Project				
Land at Tappers Farm	Date	Status		
Oxford Road, Bodicote	28.09.23	28.09.23 Planning		
Drawing Title	Scale	Drawn by	Checked by	
Elevations compared:	1:100 @ A1	CAB	-	
REM approved and	Project No.	Drawing No.	Revision	
Tech design proposals	22-029	P/WC/201/ -

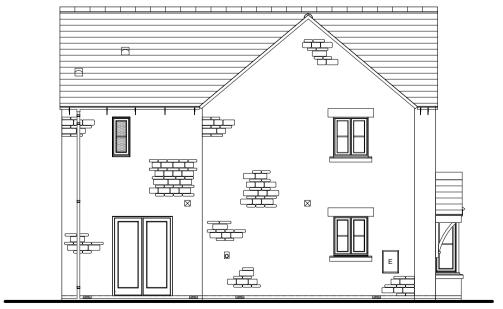
- Utility door 'B' added for amenity
- window 'D' omitted because it would face the adjoining neighbour's parking
- other windows added/omitted/enlarged to reflect Part
O audit, standard layout adjustments and enable fire
